MFN 07-295
June 8, 2007

Subject: **GE Response to NRC, "Request For Additional Information Related To Advanced Boiling-Water Reactor Licensing Topical Report (TAC NO. MD4025)," Regarding Alternate RCIC Turbine-Pump Design**

**Licensing Topical Report NEDE-33329P
“Advanced Boiling Water Reactor (ABWR) With
Alternate RCIC Turbine-Pump Design”**

Drawings Requested by RAI-7

SCALE: 1:10 PARTS LIST ITEM NO.
GENERAL ARRANGEMENT
REACTOR CORE ISOLATION COOLING PUMP

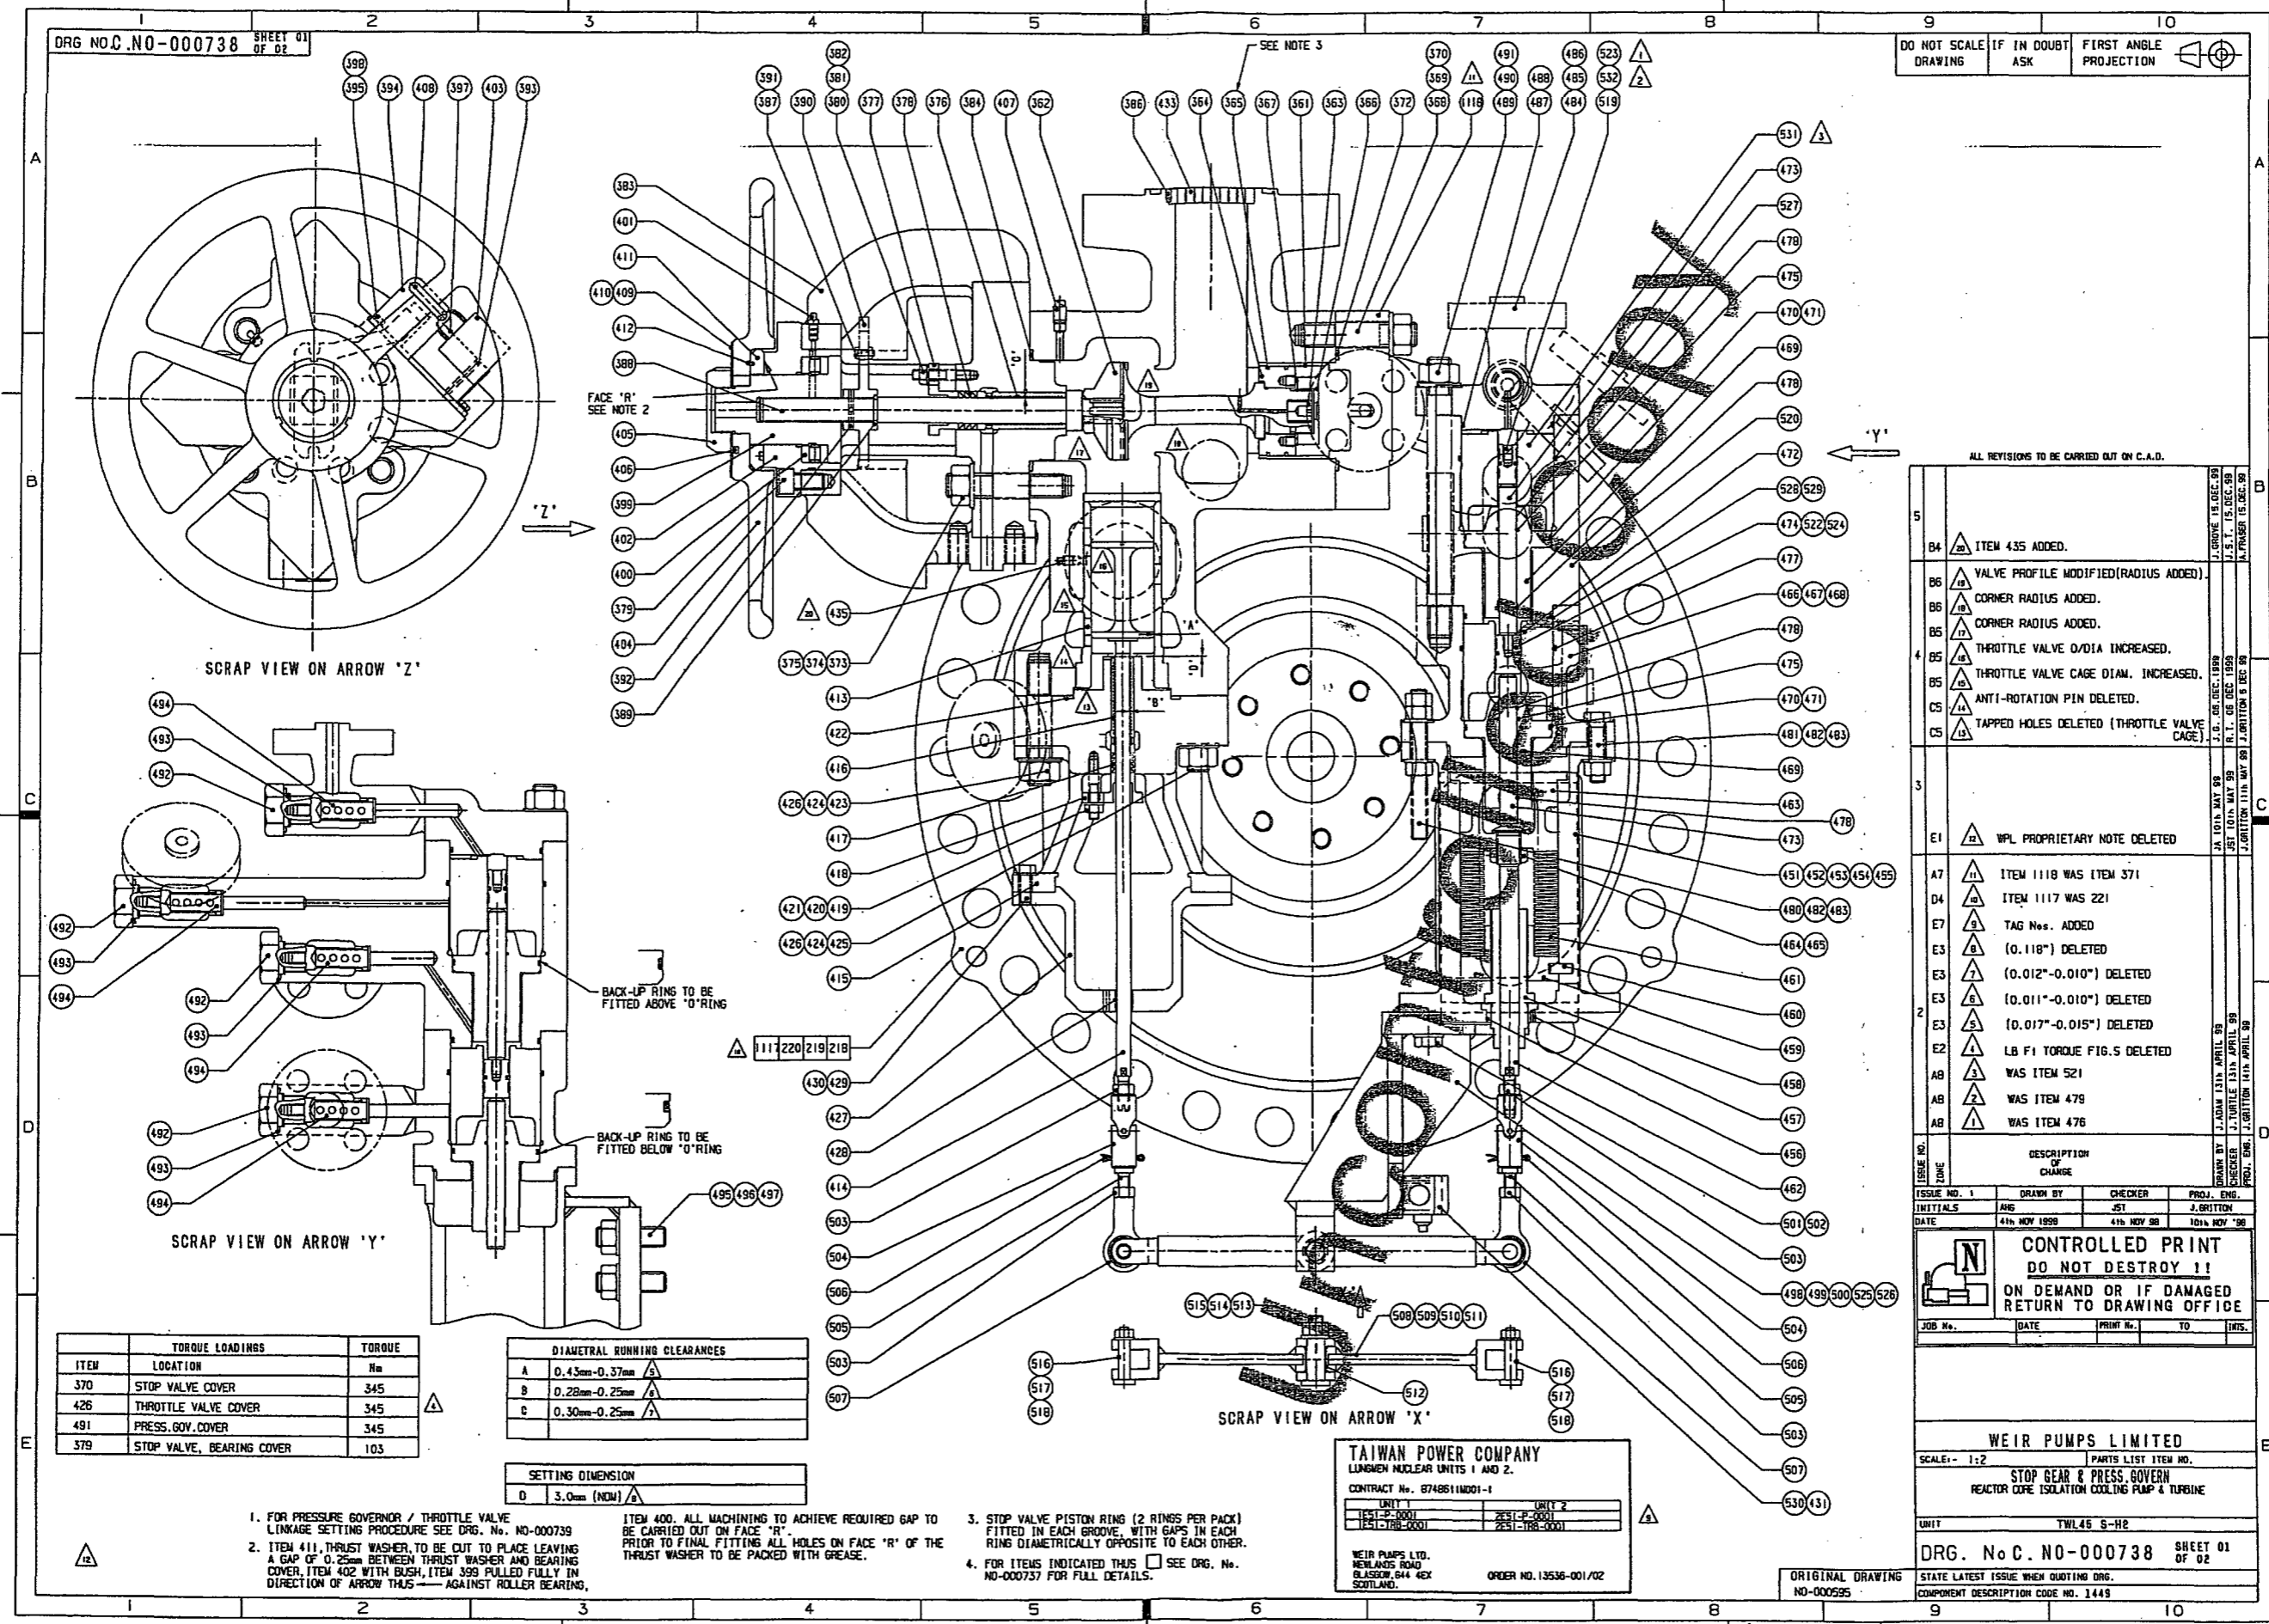
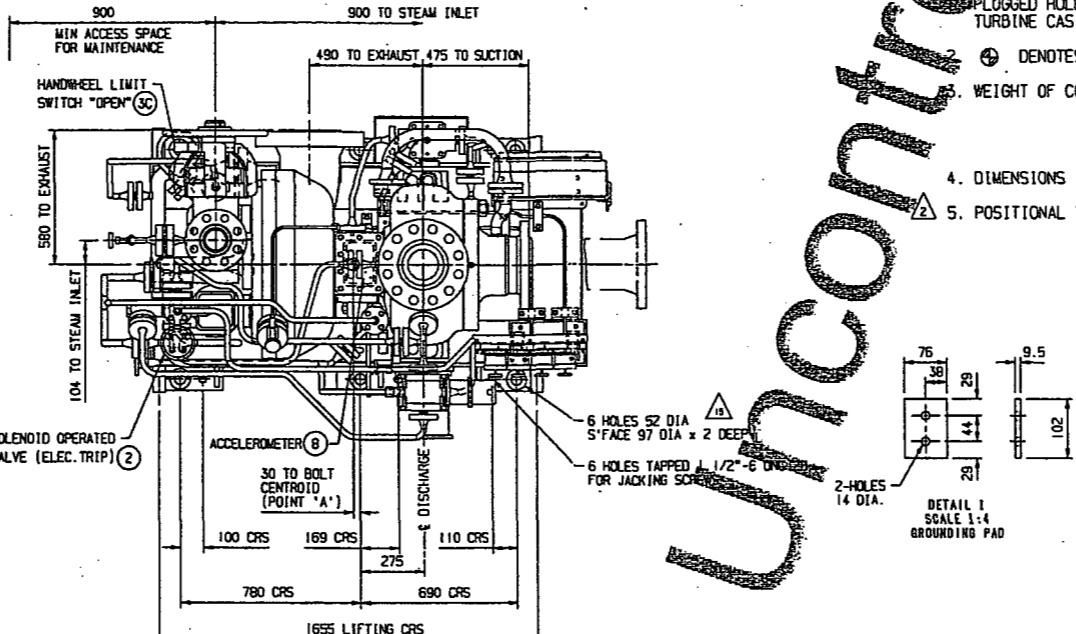
Figure 1, "TWL Type Turbine-Pump Assembly," on page 11 in NEDE-33299P provides a rough drawing of the alternate RCIC turbine-pump design. Provide a more clear detailed diagram and/or photographs of the alternate design showing the inlet, outlet, connecting lines, and instrument locations.

To assist in NRC review, detailed engineering drawings of the alternate RCIC turbine-pump design are attached in Enclosure 2.
